SECTION 905 -- PROPOSAL (CONTINUED)

| Number | Description |
|--------|---|
| 1 | Revise Table of Contents, replace same; Add NTB Nos 4658, & 4662; Revise Bid Items, replace same; Add or Revise Plan Sheet Nos. 2-3, 5, 8, 11-12, 14, 19, 28, 53, 55, 87, 8001-8004, 8006, 8008-8009, 8011-8013, 8017, 8019, 8027, 8029-8030, 8032, 8034-8037, 8042, 8048-8051, 8053, 8055-8056, 8062, 8068; Amendment EBS Download Required. |

BR-0019-02(041) / 105189301

Bridge Replacements on SR 7 at Bridge Nos. 154.0, 154.8, 155.0, known as Federal Aid Project No. BR-0019-02(041) / 105189301 in Marshall County.

WORKING NUMBER: EQ-5
 SHEET NUMBER: 19

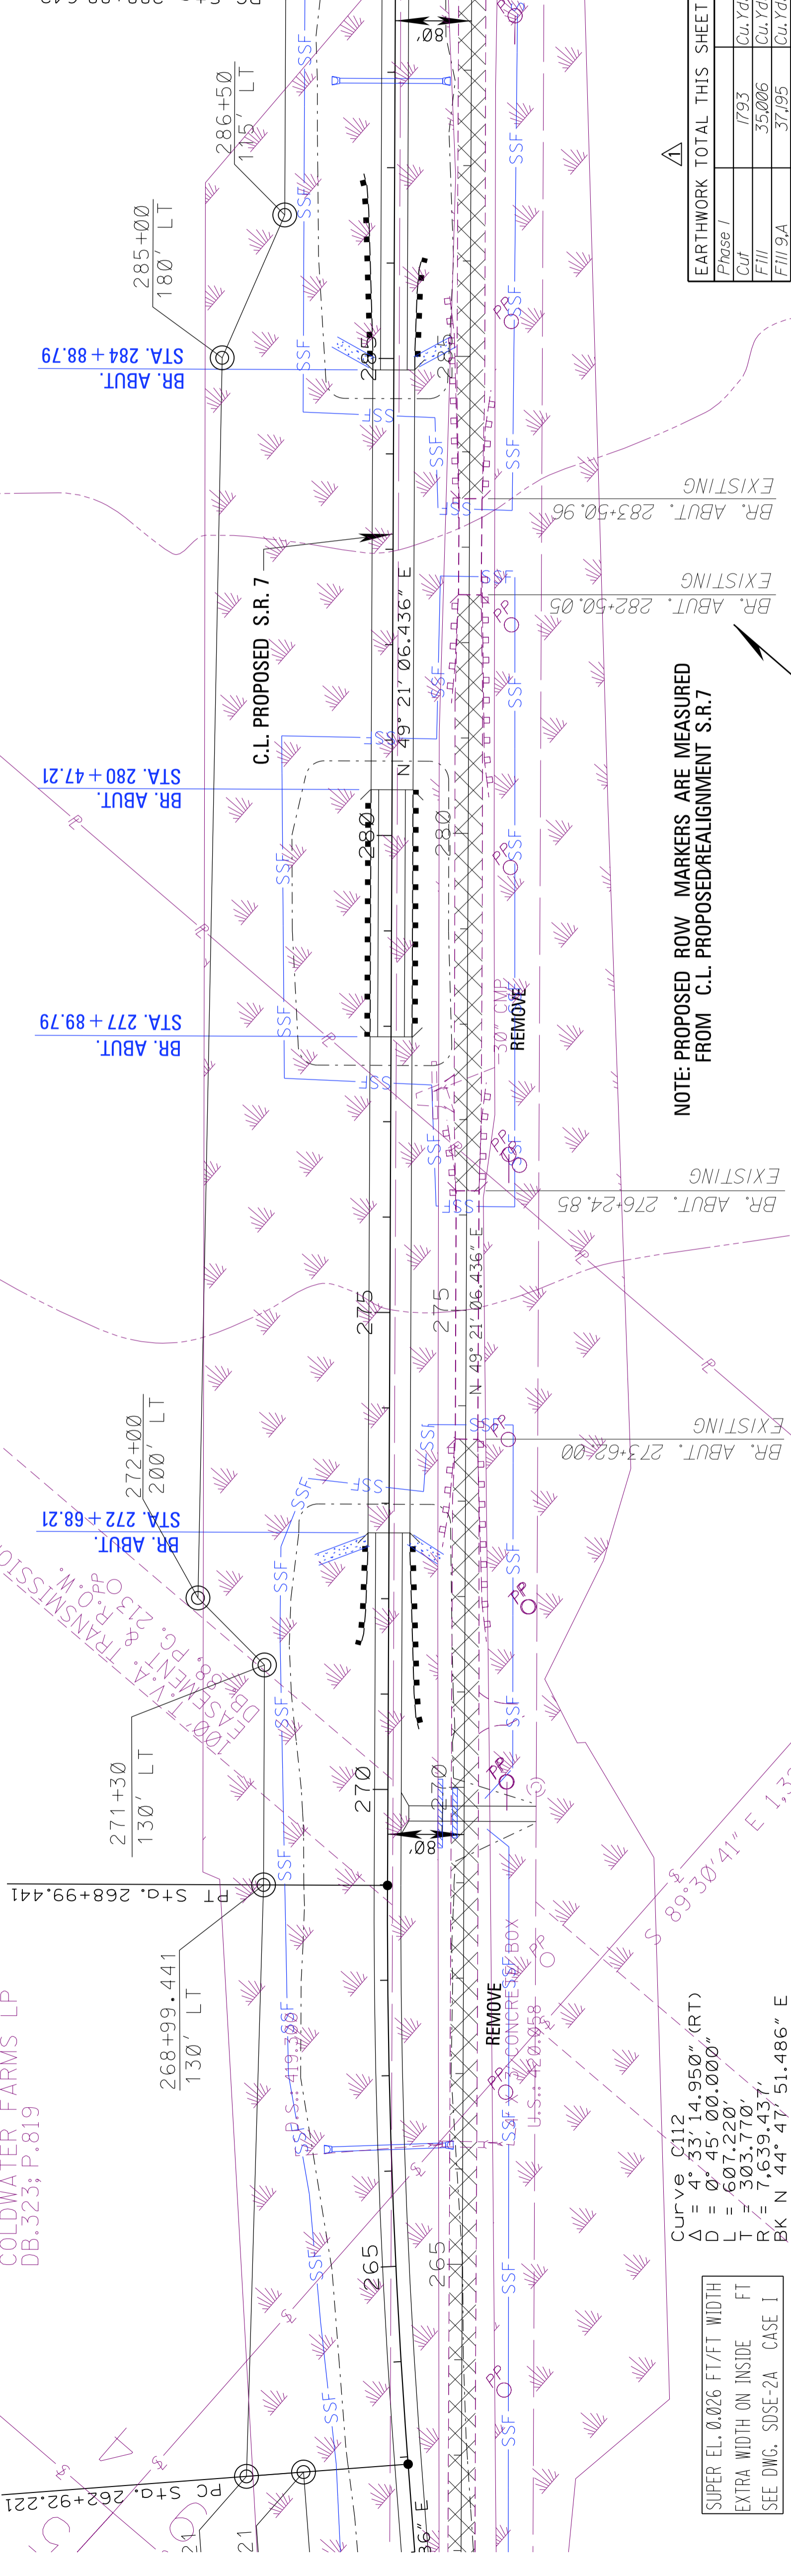
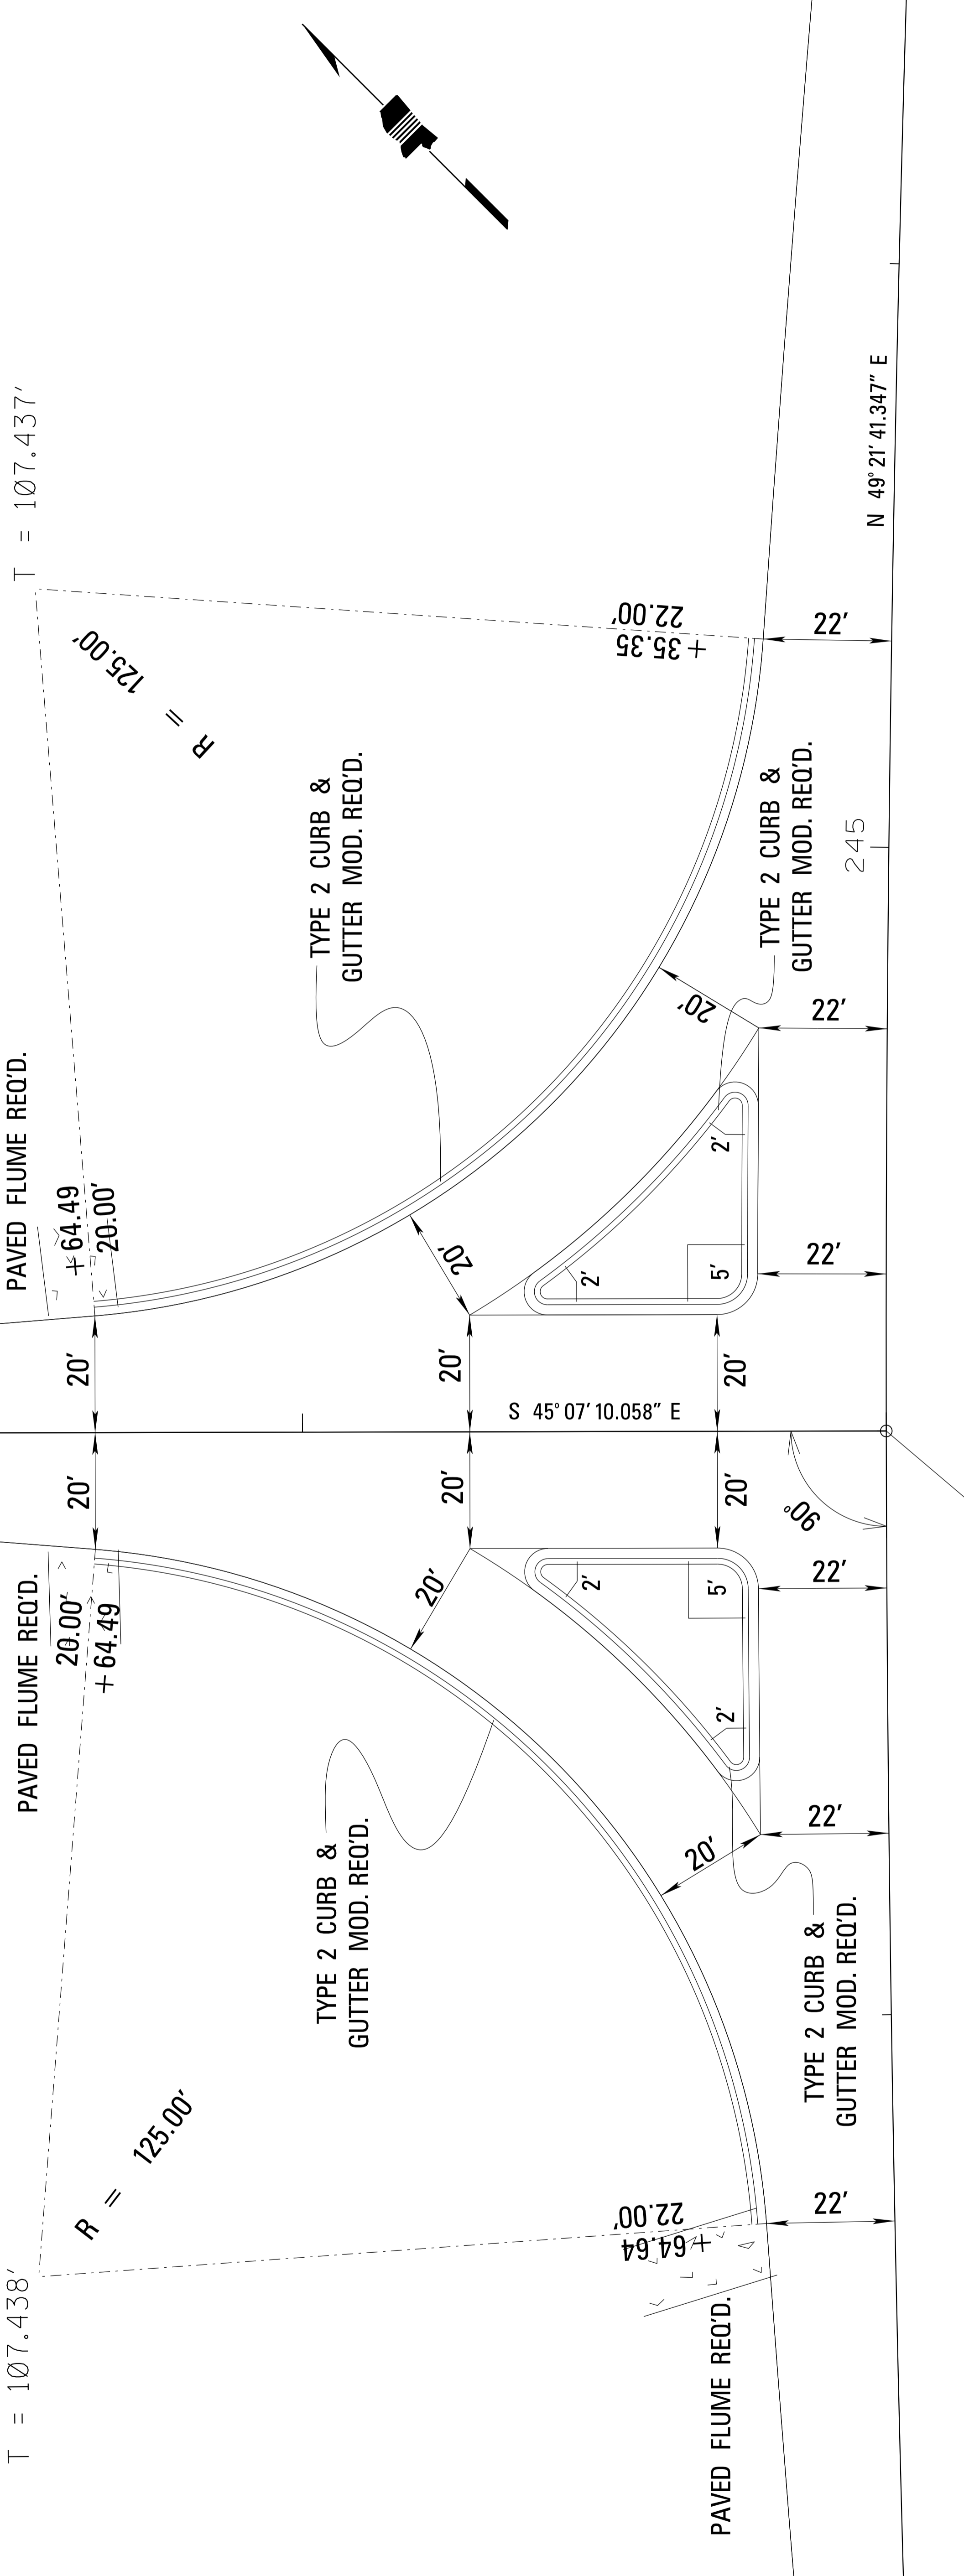
NOTE: REMOVAL OF EXISTING EMBANKMENT IN WETLANDS TO NATURAL GROUND BETWEEN STA. 225+00 - STA. 235+00 AND STA. 261+00 - STA. 297+00 SEE X-SECTIONS FOR MORE DETAIL

REVISED NOTE AND EARTHWORK

| MISSISSIPPI DEPARTMENT OF TRANSPORTATION BRIDGE AT STA. 229+81.21 SR 7 OVER COLDWATER RIVER TRIB. PROJECT BR-0019-02(041) MARSHALL COUNTY WORKING NUMBER A3 OF 24 SHEET NUMBER 8006 | | |

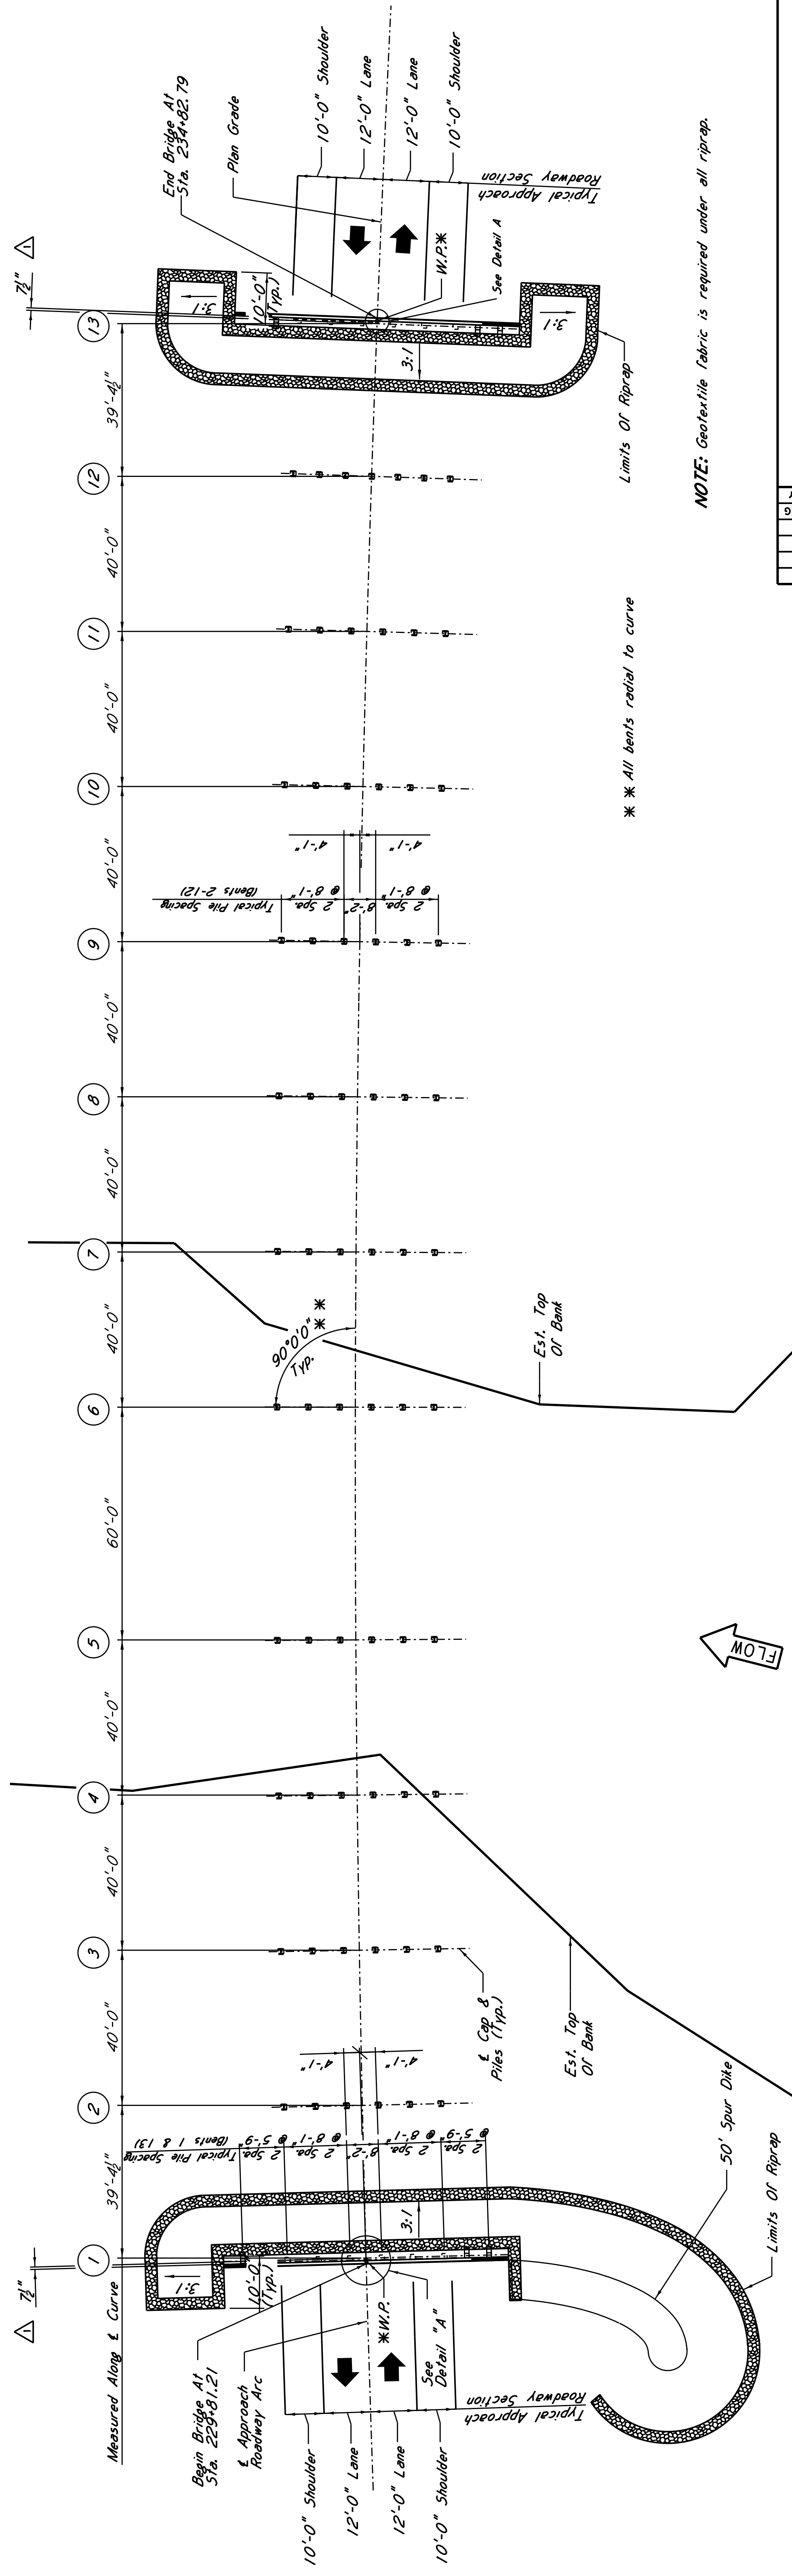
| Dimension revised | | 9-12-13 |
